TARGETED TRAFFIC RESPONSE LETTER

11 February 2025

**RESPONSE TO INFORMATION REQUEST (COM/2024/374)
PROPOSED WAREHOUSE DEVELOPMENT – DUAL TENANCY
LOT 204 VANTAGE ESTATE, YATALA**

ATTACHMENT B - SURVEYED CAR PARKING DEMANDS AT VARIOUS WAREHOUSE DEVELOPMENTS

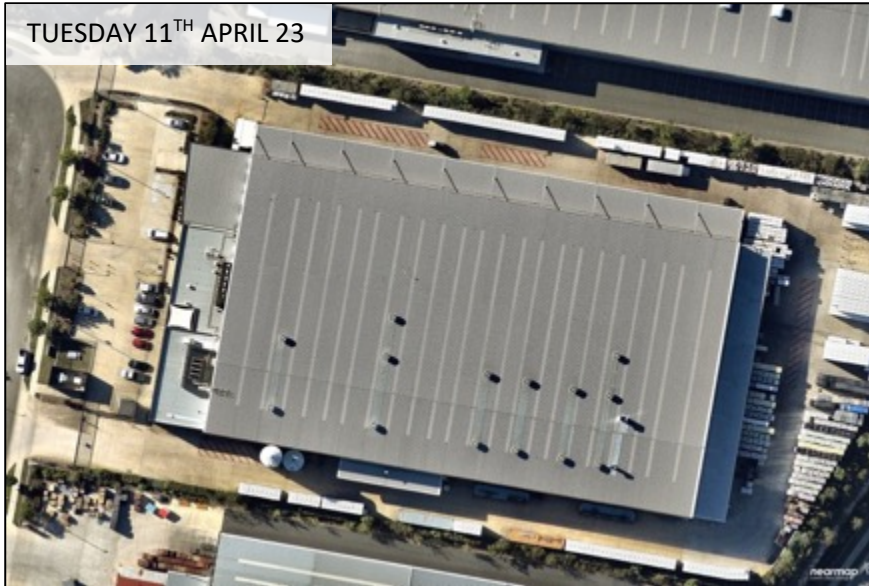
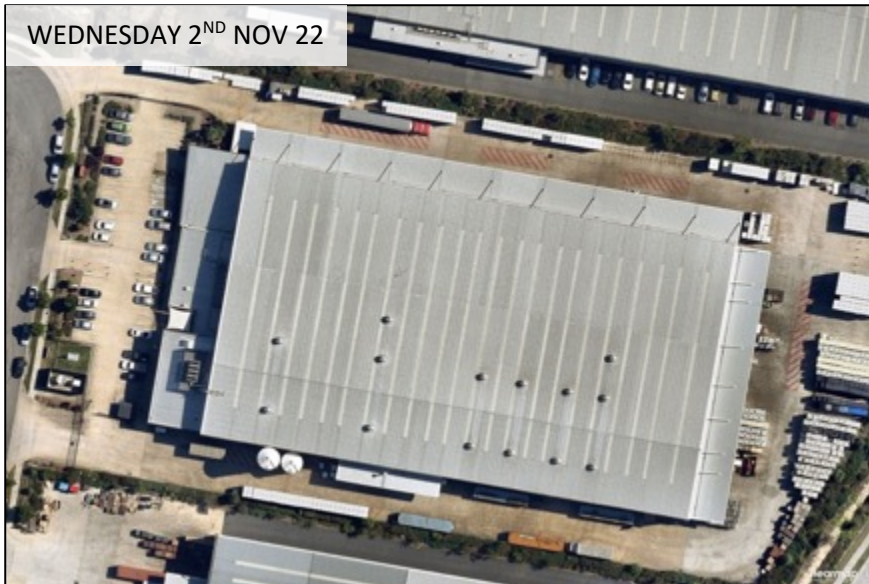
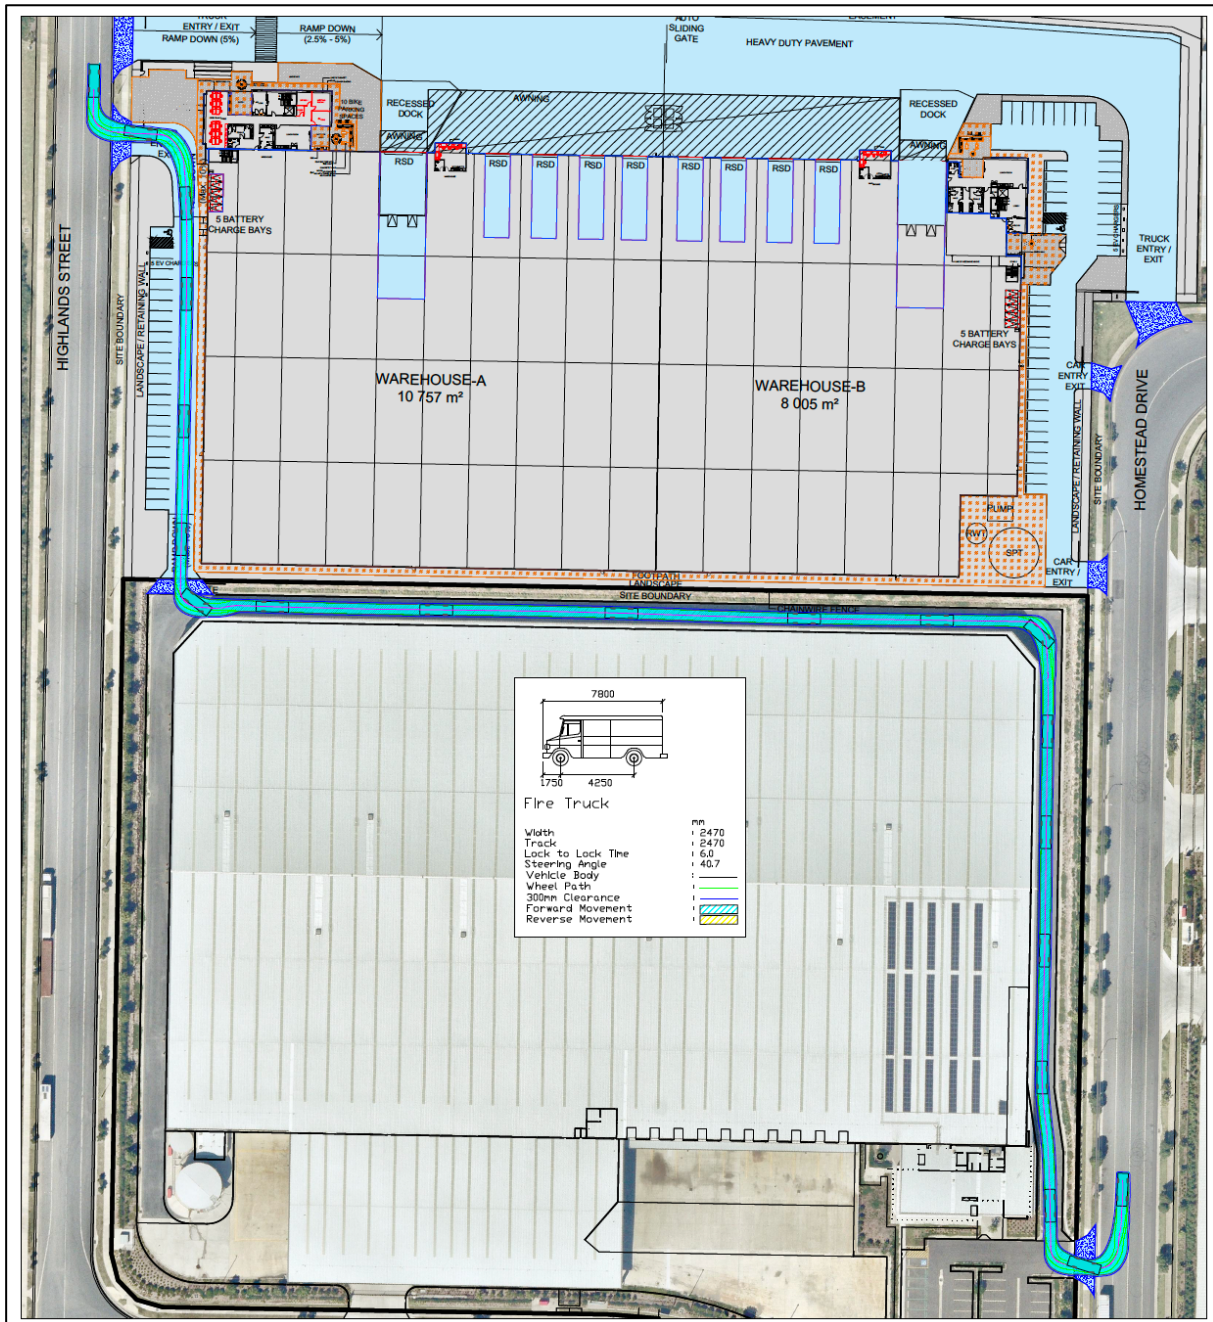
Vehicular parking – PC8 To comply with AS8.1.1, the proposed development requires 211 off-street car parking spaces. The proposal represents a significant parking shortfall, with only 121 car parking spaces proposed. The information provided in the Transport Impact Assessment does not provide sufficient justification to meet PC8. Given that the end users and specific operations for the proposed development are unknown, the applicant is requested to demonstrate compliance with the prescribed parking rate. Alternatively, suitable and sufficient justification shall be provided to demonstrate that the expected parking demand will be fully accommodated on-site, in accordance with PC8 noting the above identified noncompliance with the Performance Criteria.

As depicted in Attachment A, a review of car parking utilisation has been carried out using Nearmap aerial imagery. As shown, the surveyed sites indicate low car parking utilisation, with car parking rates as low as 1 space per 600m² GFA. For the above reasons, the proposed provision of 121 car parking spaces will adequately service the proposed building without causing an overflow of parking demand into the public street system.

As shown in Table 4.2, the surveyed sites indicate low car parking utilisation, with car parking rates as low as 0.17 spaces per 100m² GFA. RTE has been involved in many large warehouse unit developments and find that the rates shown below are typical of user requirements.

ATTACHMENT B – SWEEP PATH ANALYSIS (FIRE TRUCK)

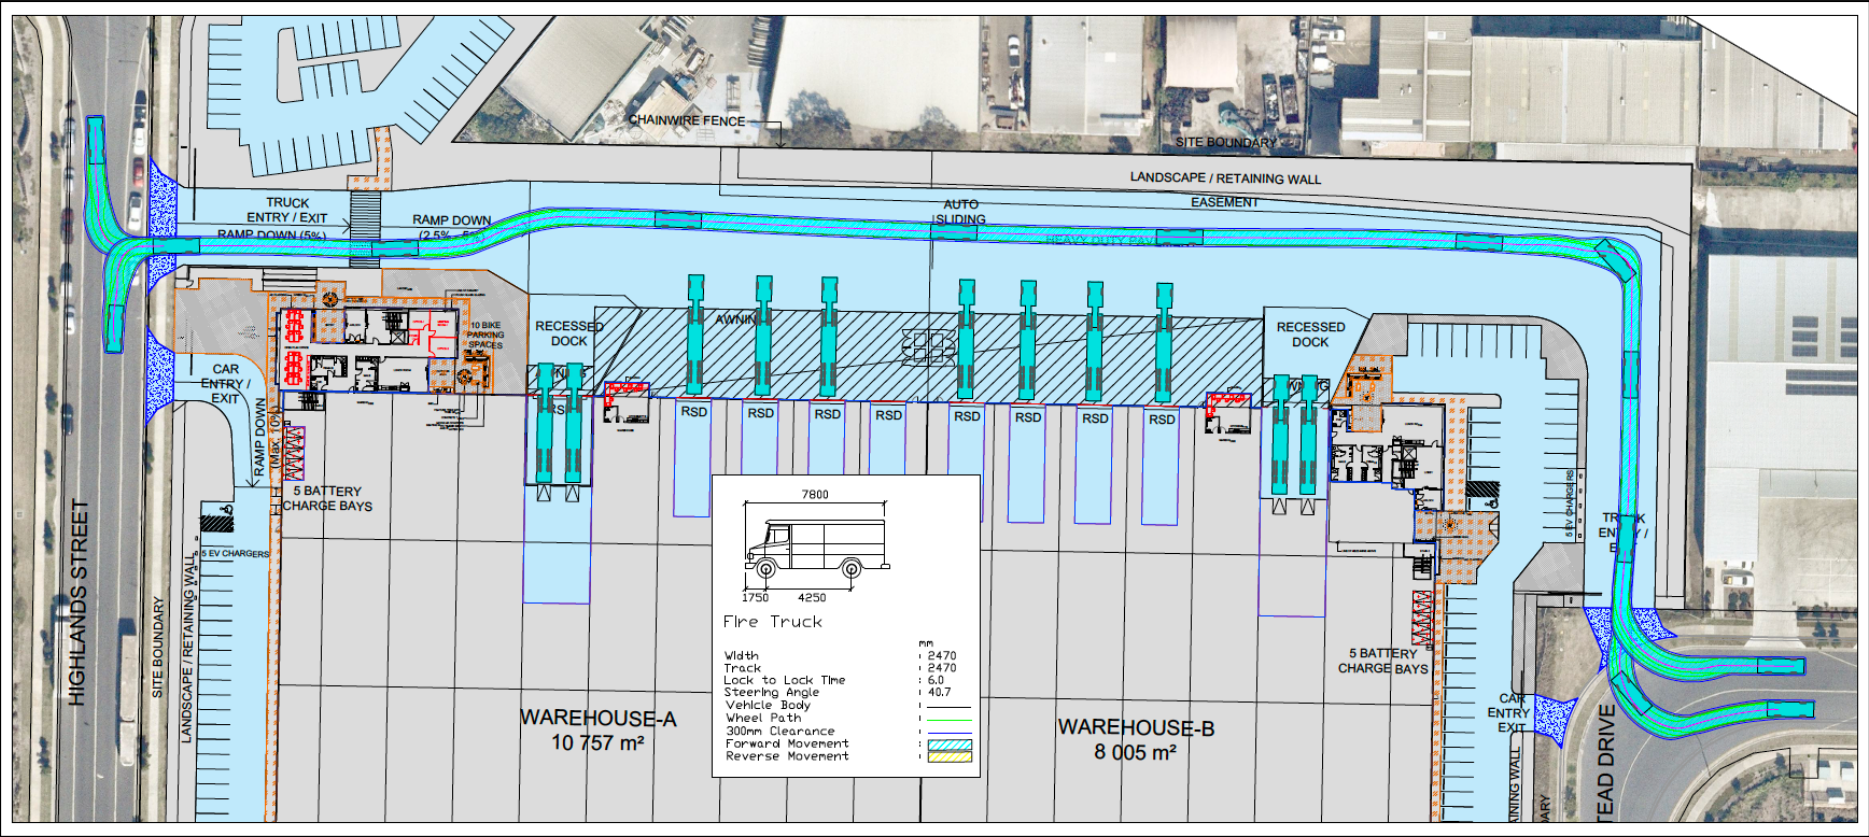
Submit a swept path to demonstrate that a fire truck is able to circulate from Lot 204, to the proposed easement in Lot 205 (and through Lot 205), with all movements achieved in a continuous, forward motion.

As shown in Attachment B, a swept path analysis has been carried out and demonstrates that a fire truck can circulate from Lot 204 to the proposed easement in Lot 205, and through Lot 205, with all movements achieved in a continuous forward motion.

ATTACHMENT C - PROPOSED SITE PLAN

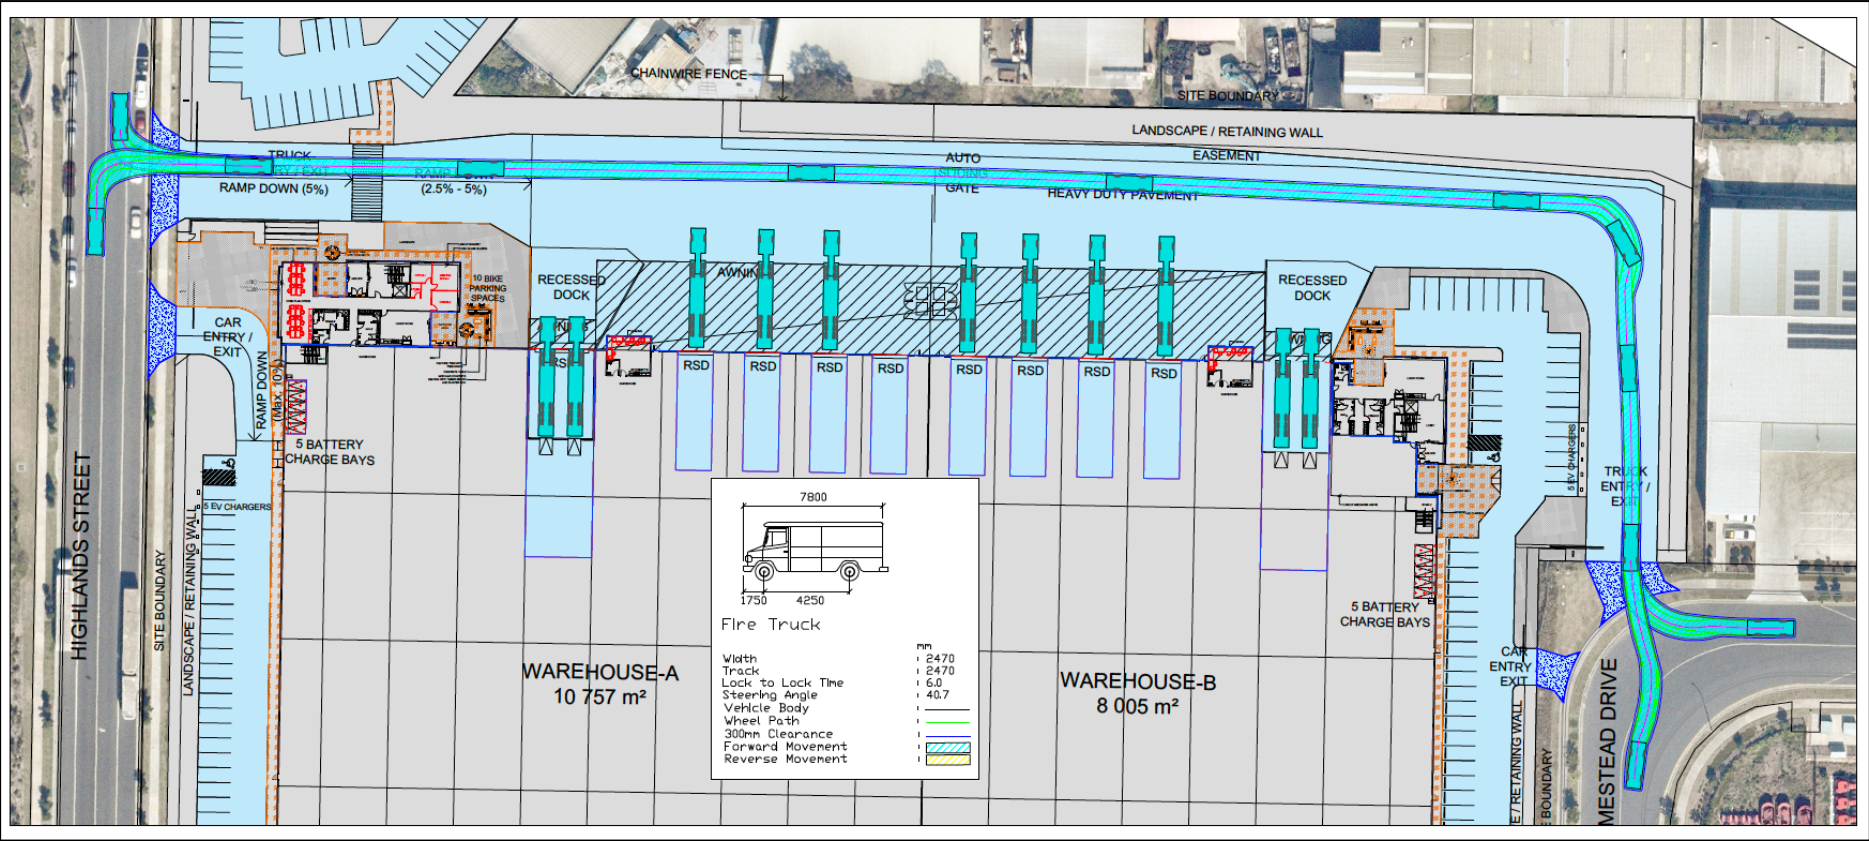
Dimensions, for all car parking and servicing facilities, shall be shown on development drawings (not just on figures within the Transport Impact Assessment). Car parking facilities shall be designed in accordance with the relevant 'User Class' requirements of AS2890.1 (for both staff and visitor use), and surface gradients shall be identified; dimensions shall be shown for all service bays, with notations shown on development drawings to clearly identify service bays (within the building); pedestrian sight triangles shall also be dimensioned, and the relevant notation amended to read: "Pedestrian sight triangles to be kept clear of obstructions to visibility. Low level landscaping permitted to a maximum mature height of 500mm above driveway level."

Section 7.0 of the Transport Impact Assessment states that "The proposed development provides a secured bicycle parking facility, suitable for 10 bicycles, adjacent to the office." The proposed bicycle facility shall be clearly identified on development drawings.

The development plans have been amended to include dimensions for all car parking and servicing facilities directly on the drawings, in accordance with AS2890.1. Refer to Attachment C.

The development plans have been amended to clearly identify the proposed secured bicycle parking facility, accommodating 10 bicycles. Refer to Attachment C.

ATTACHMENT D - SWEEP PATH ANALYSIS (FRONT LIFT REFUSE COLLECTION VEHICLE)

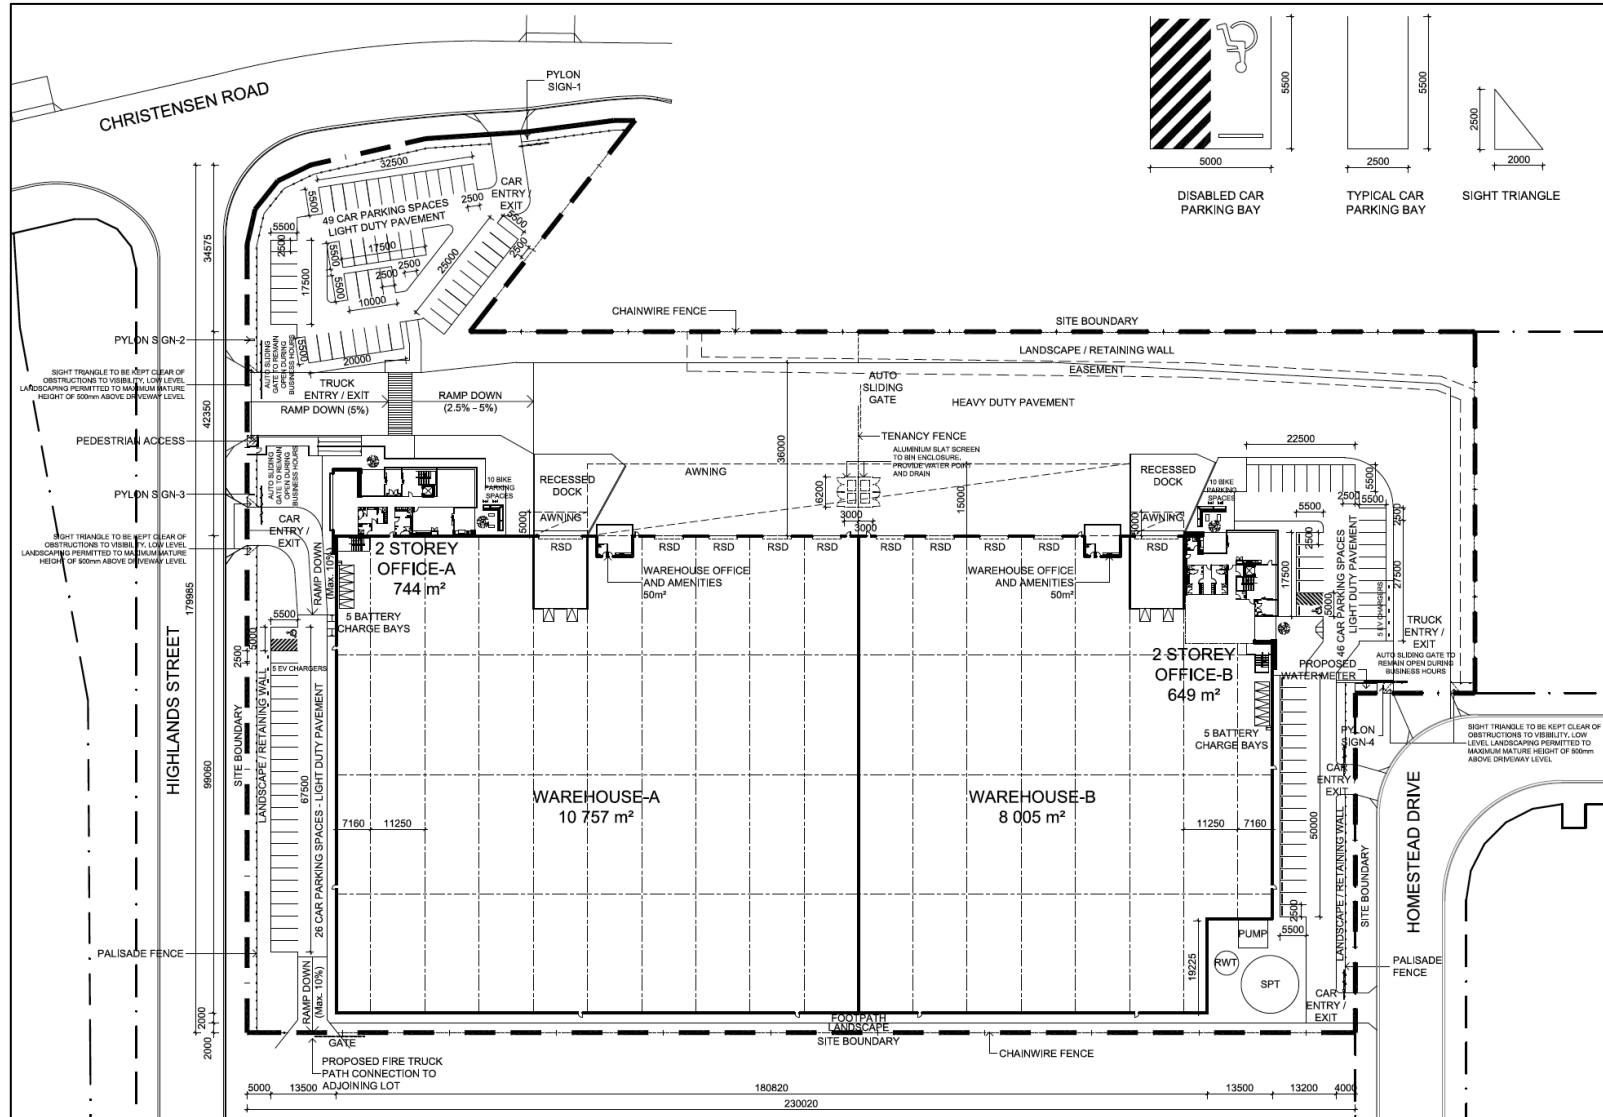
Council acknowledges the Transport Impact Assessment report '24260', version 2 dated 16 December 2024 by Rytenskild Traffic Engineering which does not demonstrate how the CoGC front-loading refuse collection vehicle will service the designated refuse storage areas whilst moving unimpeded through the site.

- a. Ensure sufficient access and clearance for the waste collection vehicles to service the bins by providing swept paths for a waste collection vehicle servicing both warehouses.
 - i. Swept path analysis is to be generated by AutoTurn, AutoTrack or similar.
 - ii. Plans must demonstrate vehicle specifications including dimensions and the wall-to-wall turning radius of the design service vehicle.
 - iii. Manoeuvring clearances in accordance with AS2890.2 must be clearly depicted on drawings and demonstrate no obstructions exist for all waste servicing manoeuvres.
 - iv. Reversing movements on-site are to be kept to a minimum and access to the development from the road is to comply with AS2890.2.
- b. Ensure the servicing point is clearly separated from car parking bays, loading bays, footpaths and pedestrian access.

As shown in Attachment D, a swept path analysis has been carried out and demonstrates that a front lift Refuse Collection Vehicle (RCV) can satisfactorily service the proposed bin store for each tenancy, and exit the development in a forward gear.
